# UNITED STATES PATENT AND TRADEMARK OFFICE

APPLICATION NO.	FILING DATE	FIRST NAMED INVENTOR	ATTORNEY DOCKET NO.	CONFIRMATION NO.
10/557,820	11/23/2005	Kwan Young Han	P2614US00	2544

<b>Office Action Summary</b>	<b>Application No.</b> 10/557,820	<b>Applicant(s)</b> HAN ET AL.	
	<b>Examiner</b> TONY TRAN	<b>Art Unit</b> 2894

## DETAILED ACTION

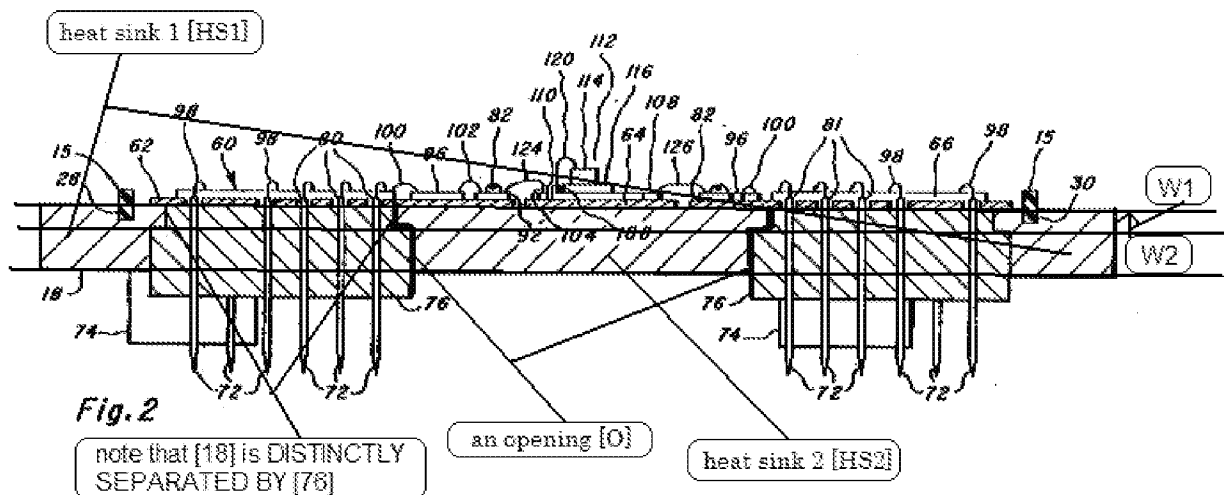
an insulation main body (76, Fig. 2, note that [76] is made of electrically insulating material, such as glass filled diallyl phthalate, col. 3, lines 32-36) having an opening to a bottom surface ([O], Fig. 2 [as shown above]);

at least two heat sinks ([HS1] & [HS2], note that as shown in Fig. 2, even though ([HS1] & [HS2]) is coming from [18], they are **distinctly separated** by the main body [76], **Fig. 12 [as shown above]**) therefore, they are considered as the two heat sinks) of electrically and thermally conductive metallic materials (([HS1] & [HS2])/[18], note that as it specifically said in col. 2, lines 65-67 that [18] is made of aluminum to provide a heat-sink), the heat sinks being separated from each other (by 76 as shown in Fig.2 above) and the at least two lead terminal (note that **[HS1] & [HS2]** are **separated** with the **two lead terminals [76s]** by the **insulation main body [76]**) and fixed to the main body (76), wherein a lower portion (bottom portion) of each of the at least two heat sinks ([HS1] & [HS2]) is exposed to the outside of the bottom surface of the main body (76) through the opening of the main body ([O]).

at least two heat sinks ([HS1] & [HS2]) of electrically and thermally conductive materials (aluminum), the heat sinks being separated from each other and fixed to the main body (76), each of the at least two heat sinks having an upper surface ([US], Fig. 2 [as shown above]) and a lower surface [LS], the lower surface [LS] of each of the at least two heat sinks ([HS1] & [HS2]) being relatively wider ([W2] > [W1] in vertical direction, **Fig. 2 [as shown above]**), note that Applicant did not claim which direction of the width) than the upper surface [US] of each of the at least two heat sinks ([HS1] & [HS2]); and

Carson, Fig. 2 teaches wherein a lower portion of each of the at least two heat sinks ([HS1] & [HS2]) is exposed to the outside of the bottom surface of the main body (76) through the opening of the main body ([O], Fig. 2 [as shown above]).

The examiner respectfully submits that as shown in Fig. 2 above [18] is **DISTINCT SEPARATED** by [76], therefore, it is considered a the two SEPARATED HEAT SINKS ([HS1] & [HS2]).

3. Carson, Fig. 2 teaches **the two heat sinks** wherein a lower portion of each of the at least two heat sinks ([HS1] & [HS2]) is exposed to the outside of the bottom surface of the main body (76) through the opening of the main body ([O], Fig. 2 [as shown above]).

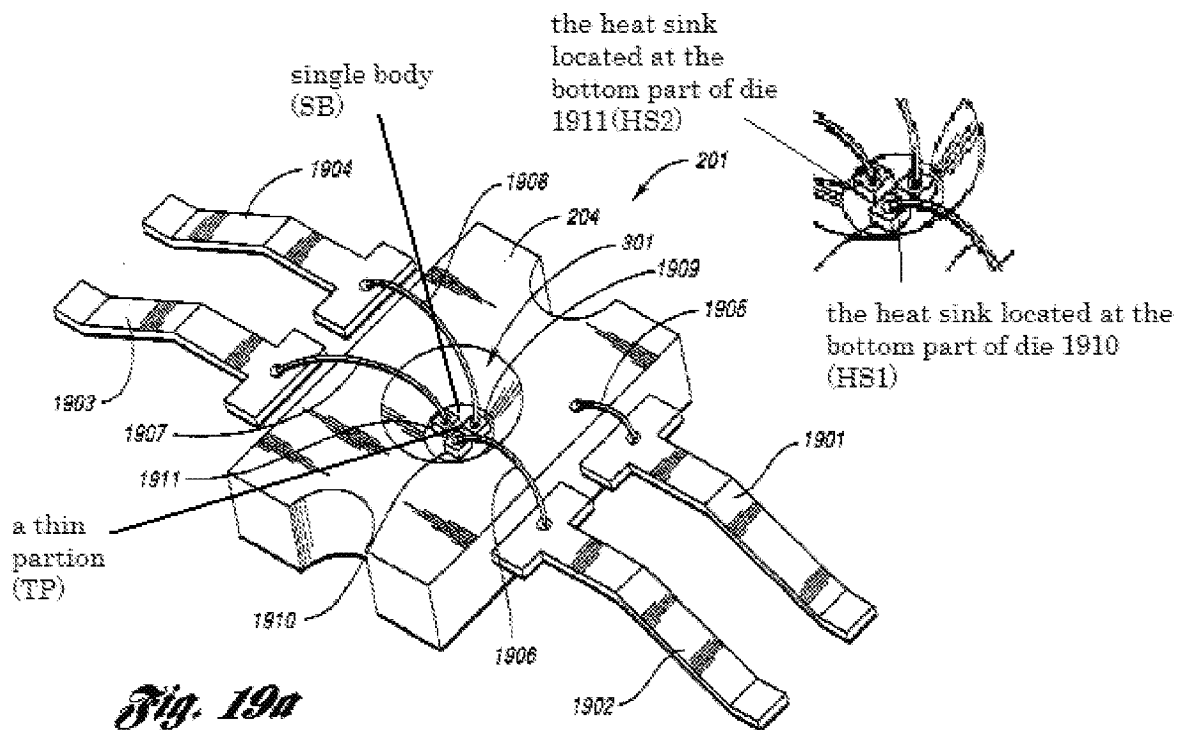
at least two heat sinks (HS1 & HS2, FIG. 19a [as shown above], note that HS1 and HS2 are sitting on top of heat extraction 204 which are conducting heat to 204

wherein the at least two heat sinks are a pair (HS1 & HS2, FIG. 19a as shown above) (claim 3).

Re claim 15, the combining of Roberts et al., one embodiment, FIGS. 19A-B further teaches the package of claim 1, further comprising at least one septum (TP, Fig. 19a [as shown above]) formed in a single body (SB) along with the main body (204) to separate the at least two heat sinks (HS1 & HS2).
